Subj: Northeast Nuclear Energy Company
(Millstone Station, Unit 3),
Docket 50-423-LA

Millstone Nuclear Power Station Unit No. 3
Response to Notice Request for Information
On The Recirculation Spray System

MP3 - RSS SYSTEM; RESPONSE TO NRC INFORMATION REQUEST DATED FEBRUARY 3, 1998

FIGURE 1A

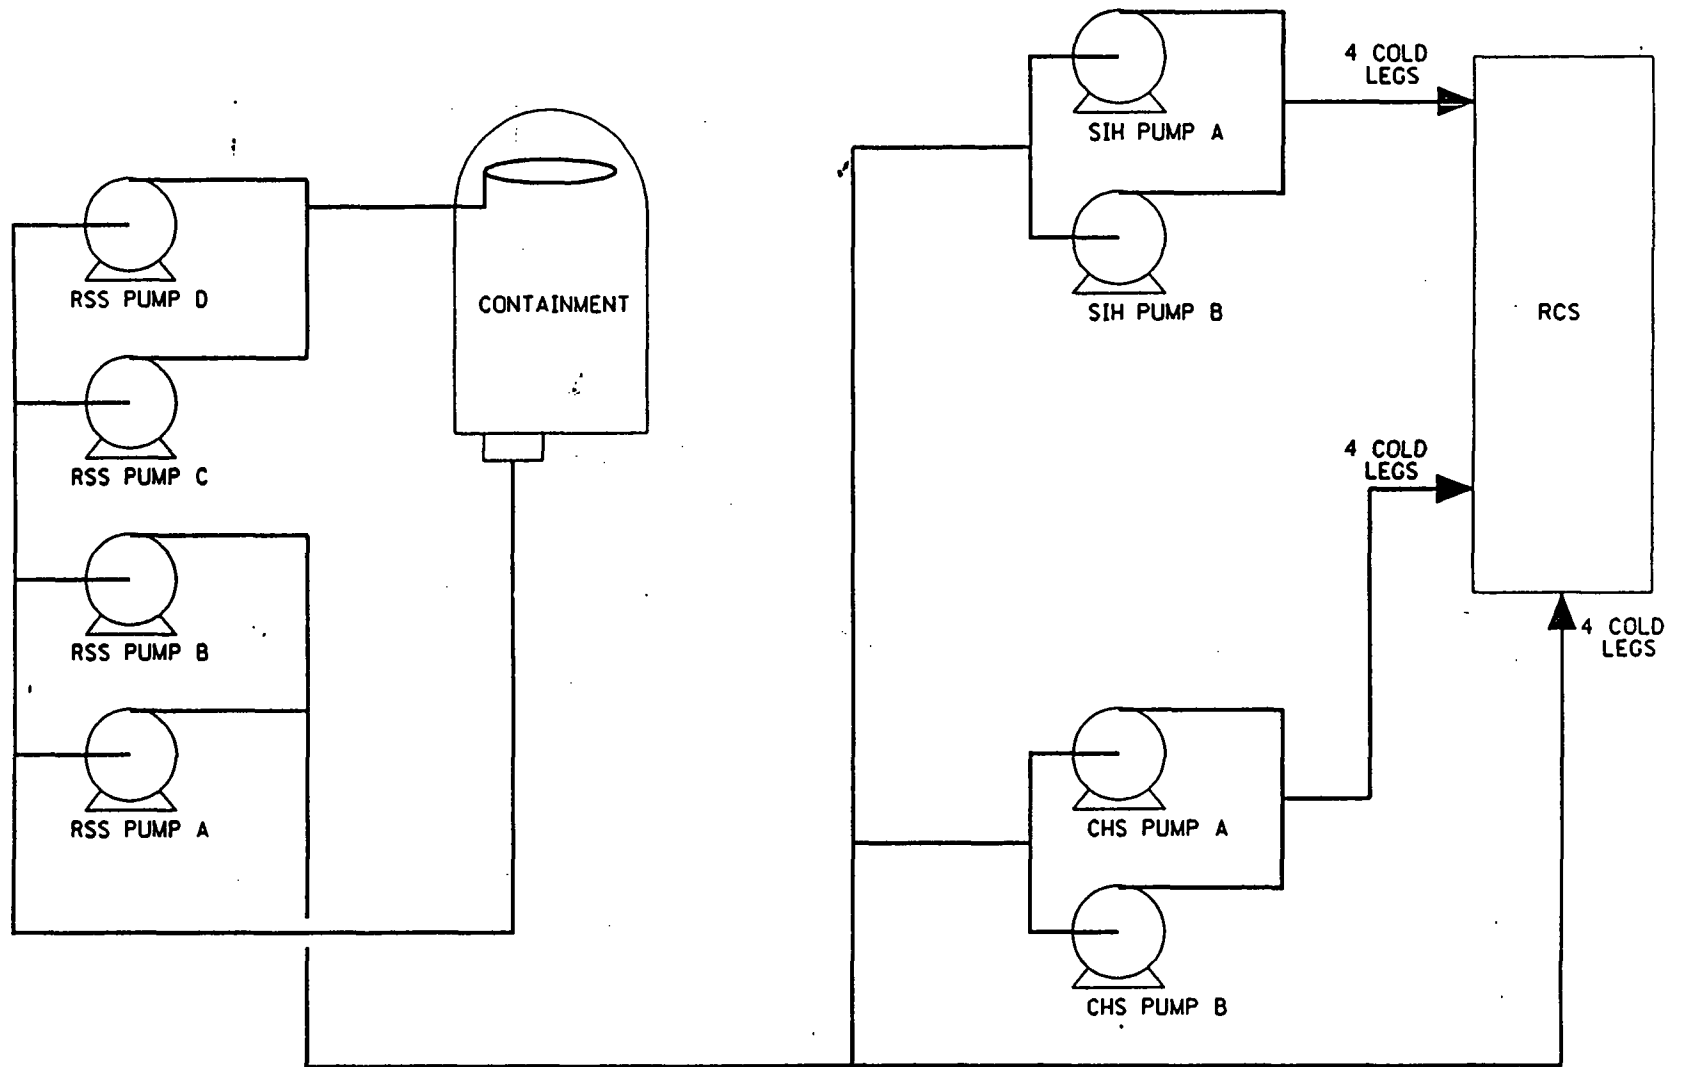
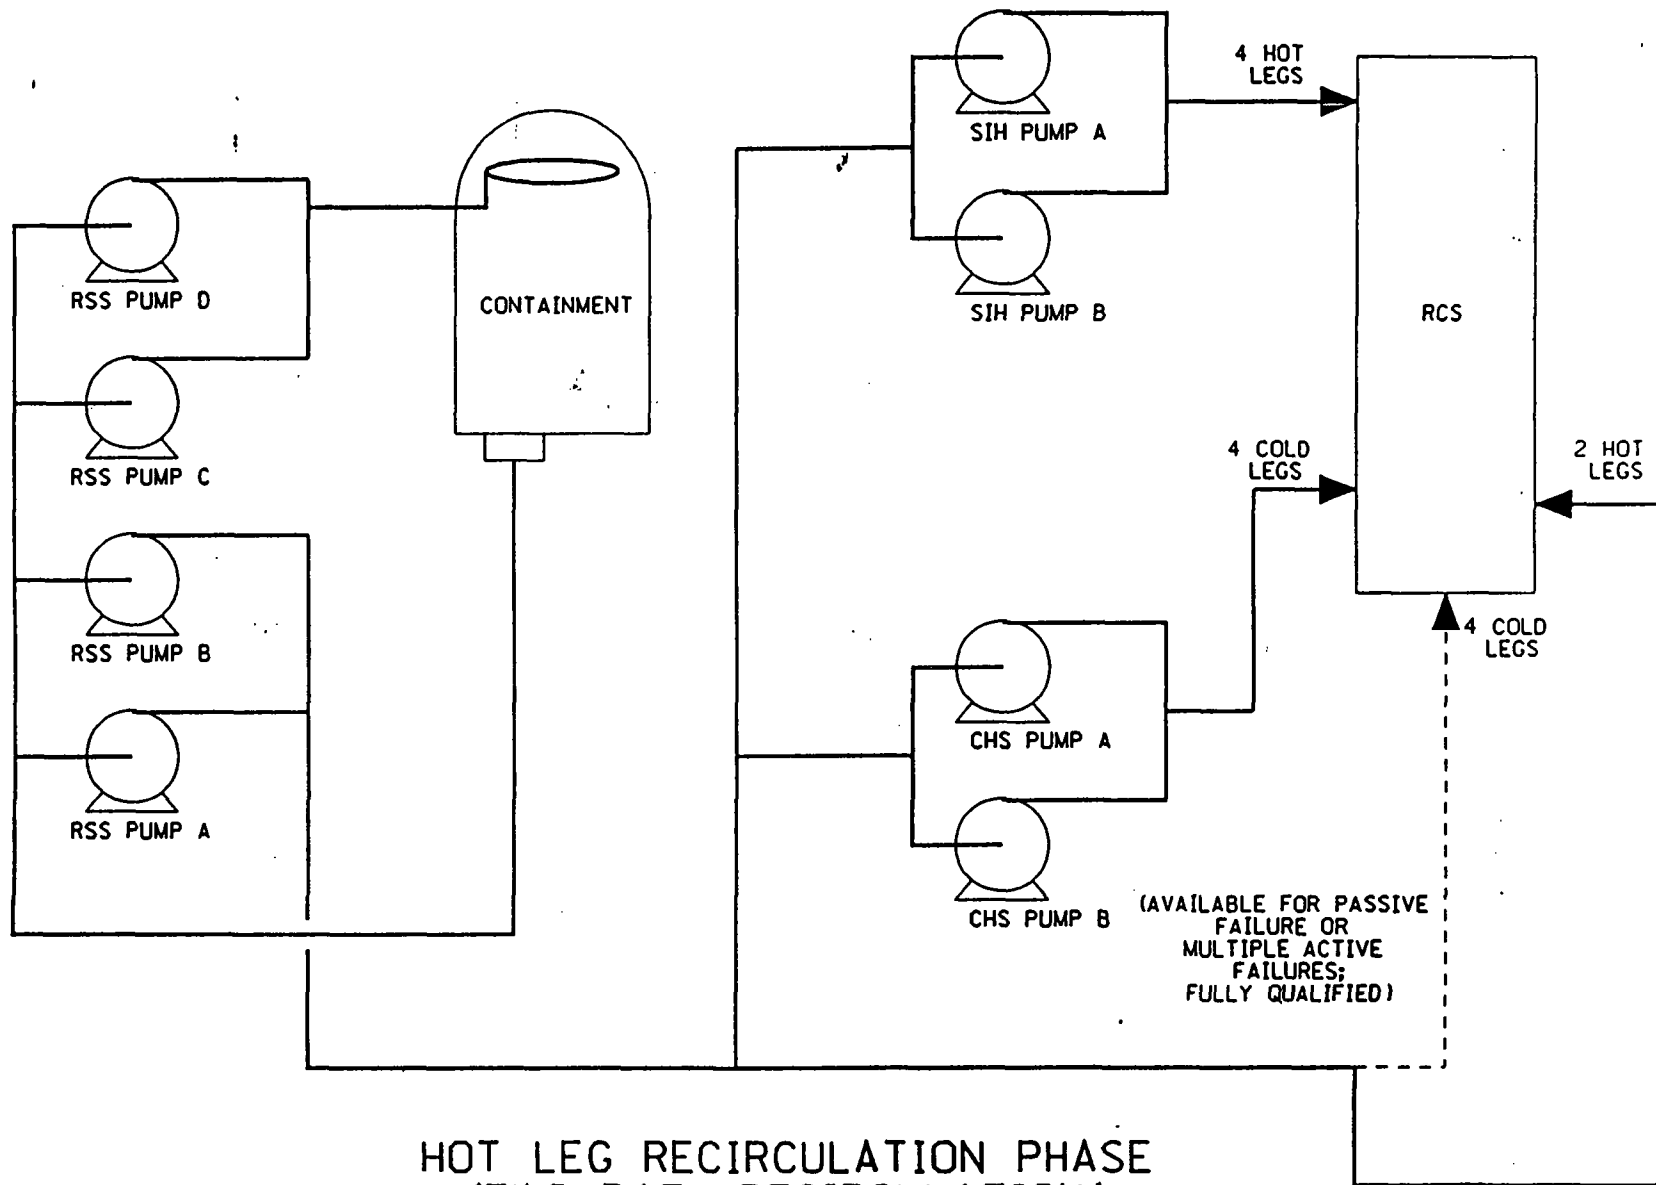
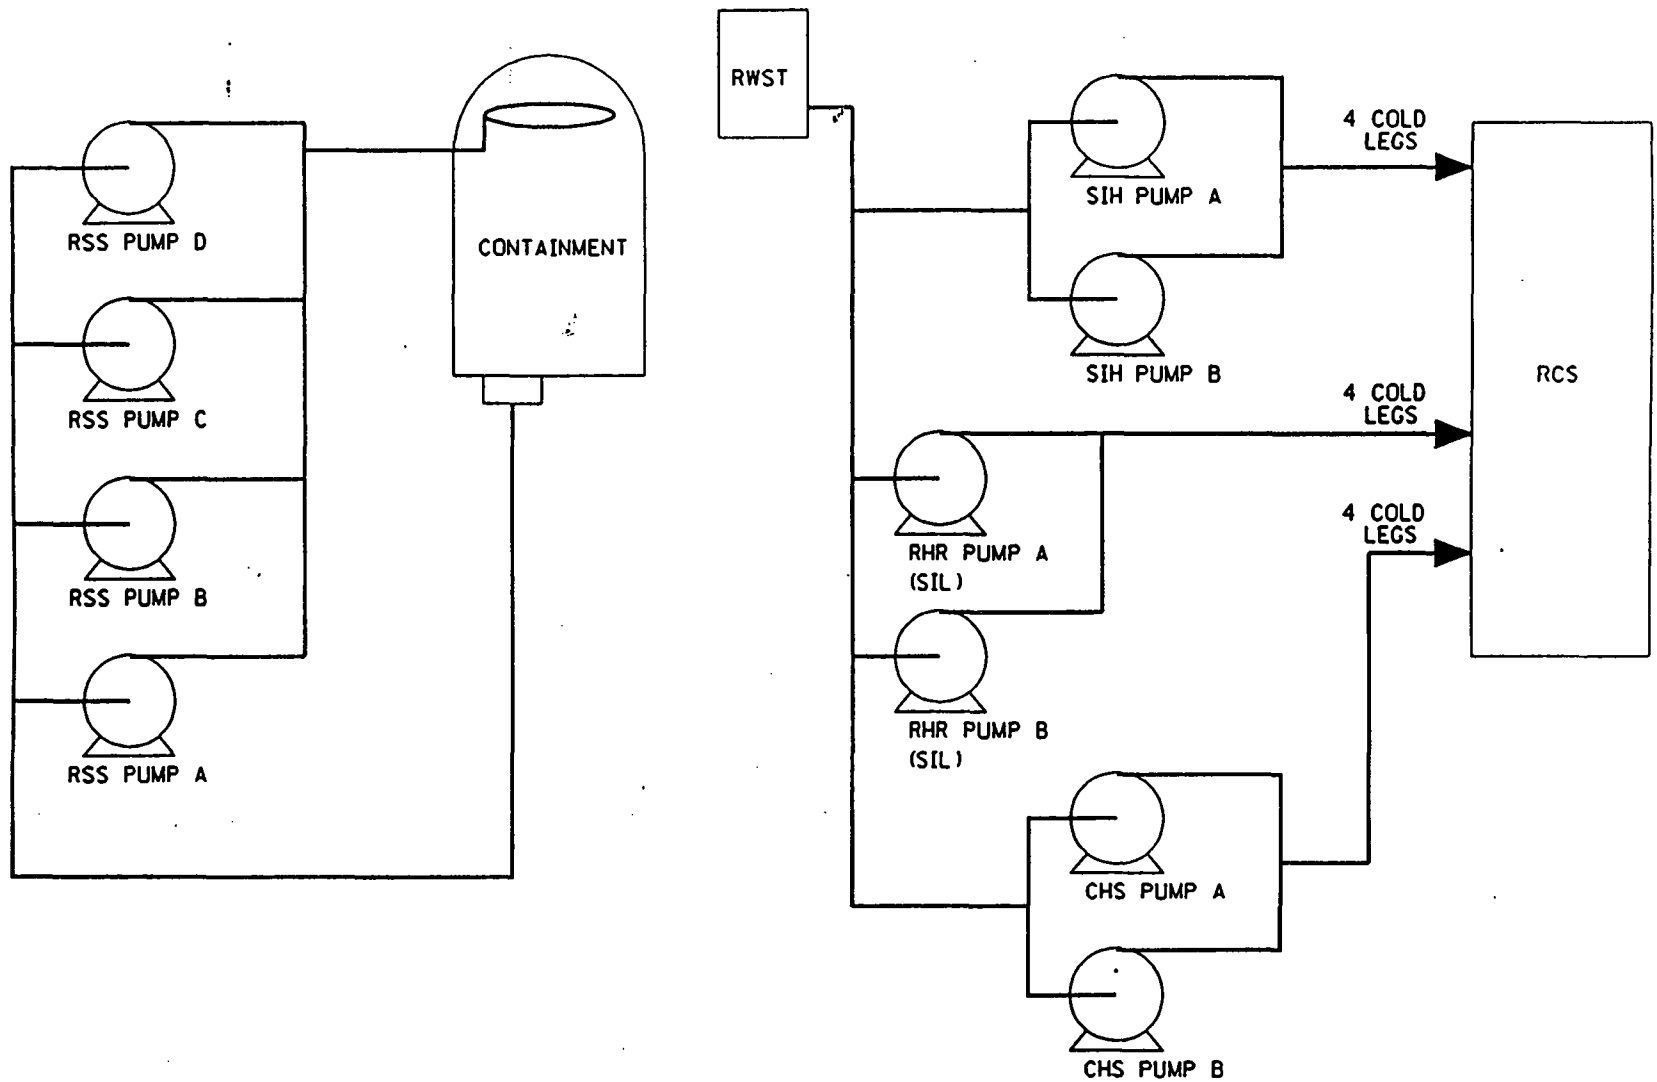
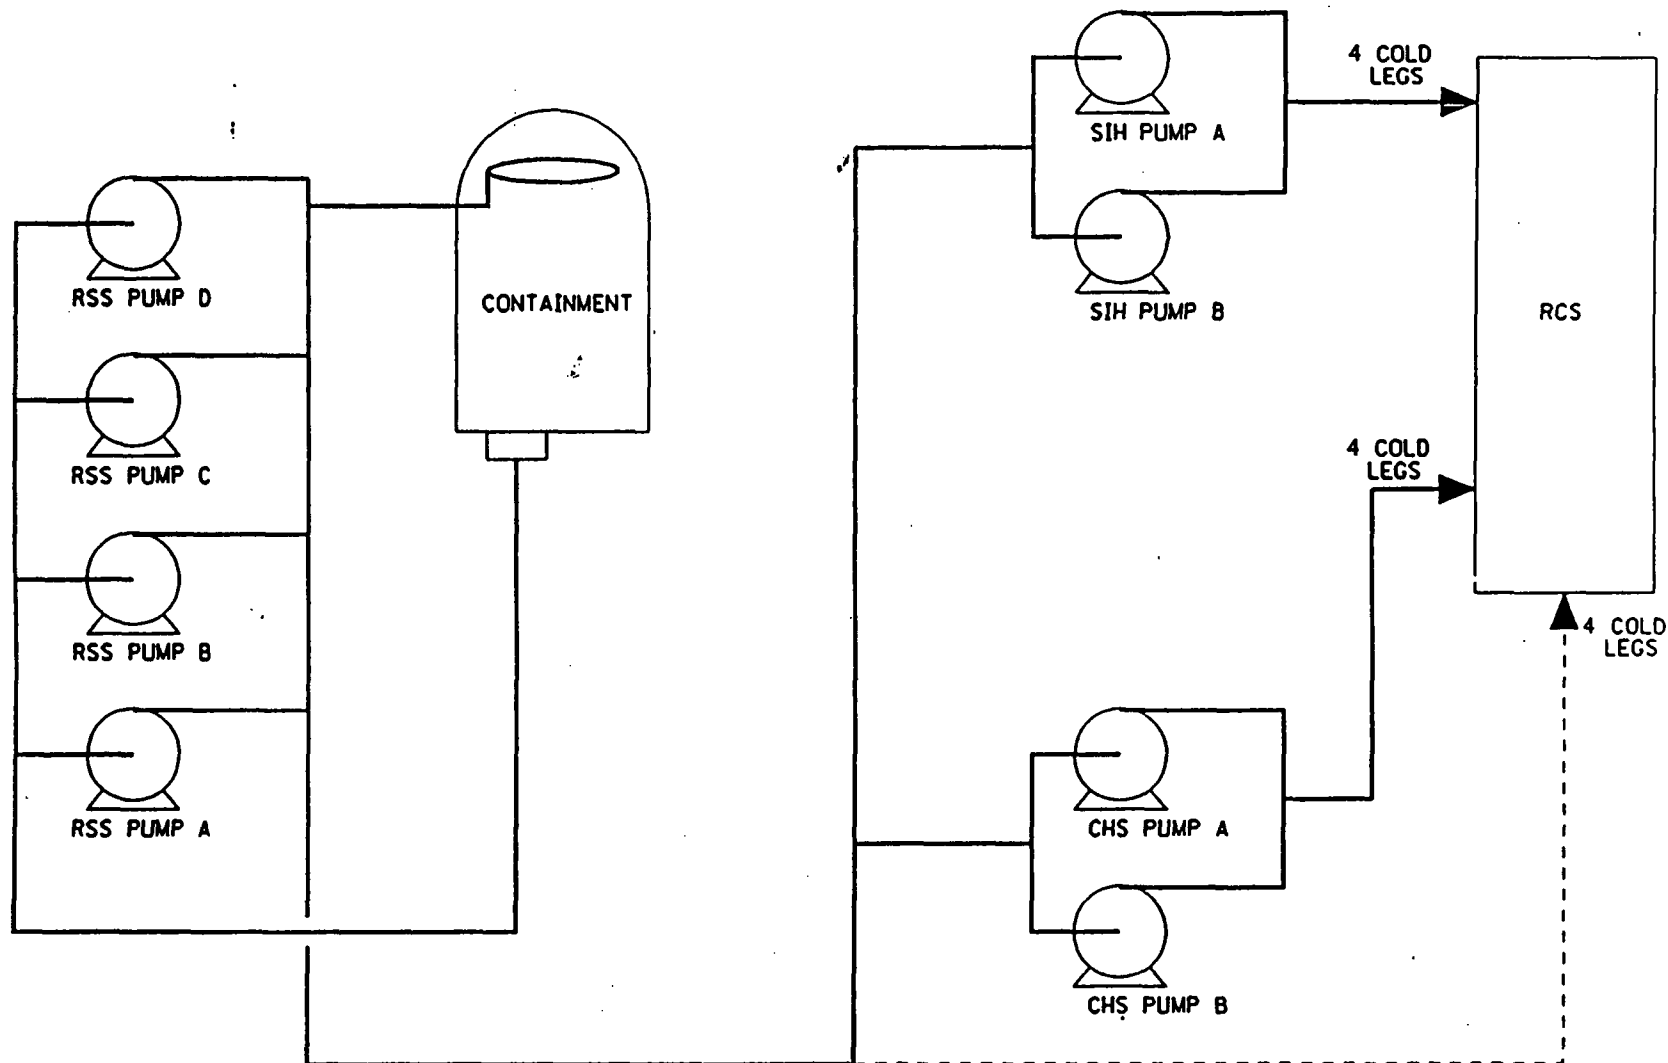
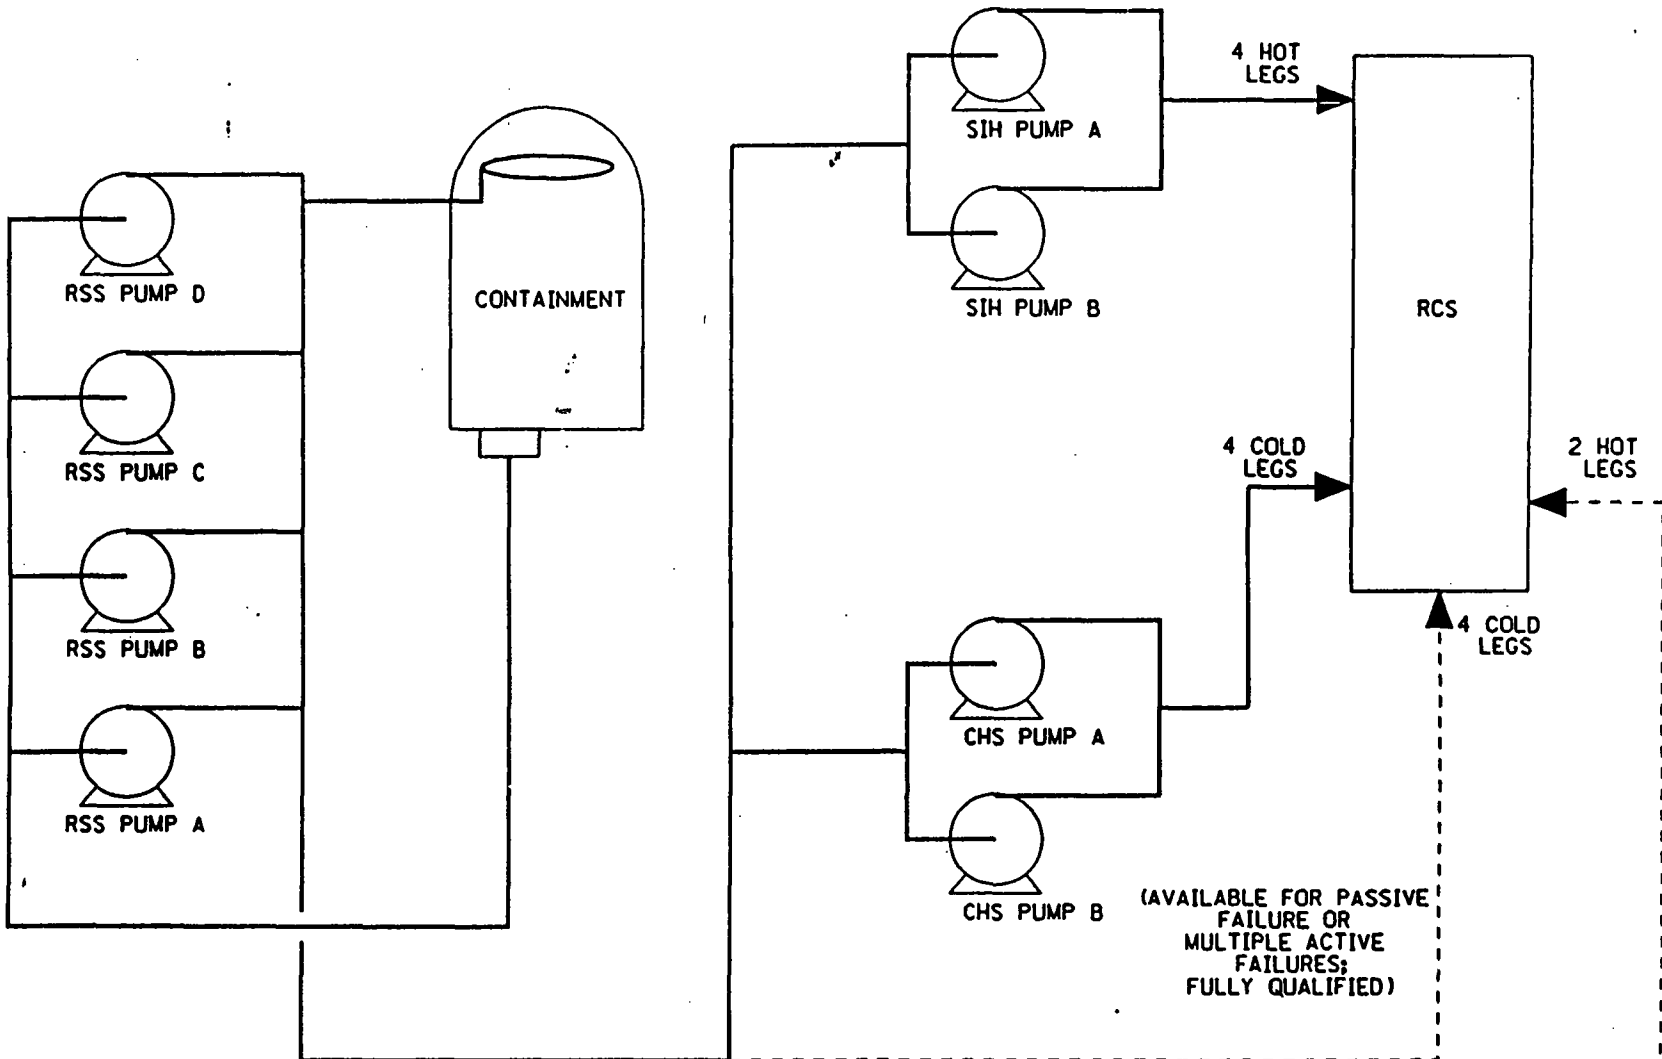
The Cold Leg Recirculation Phase operation of the system in 1998 is similar to the original 1985 alignment with two substantial changes. First the RSS pumps are not isolated from the containment spray header when they are aligned to supply ECCS cooling. These pumps will provide a dual function: ECCS injection, as well as, containment spray function. Second, the direct injection paths from the RSS pumps to the RCS cold legs are isolated to prevent direct injection to prevent tube vibration. The direct injection flow path remains available as a contingency action in the event that charging and SIH become unavailable. This alignment is depicted in Figure 2B and is controlled by the EOPs.

The Hot Leg Recirculation Phase operation of the system in the 1998 configuration differs from the original 1985 alignment in that 1) the RSS pumps are not isolated from the containment spray header when they are aligned to supply ECCS cooling, and 2) the direct injection path from the RSS pumps to the RCS hot leg is not opened. The 1998 flow paths are shown in Figure 2C.

The direct injection paths of the RSS pumps to the cold legs are available to the operators as contingencies for mitigating situations in which at least one SIH and one charging pump are not available (Figure 2C). These situations could arise either as a result of multiple failures or from isolating certain limited passive failures in the ECCS. The use of these contingencies are controlled by the EOPs.
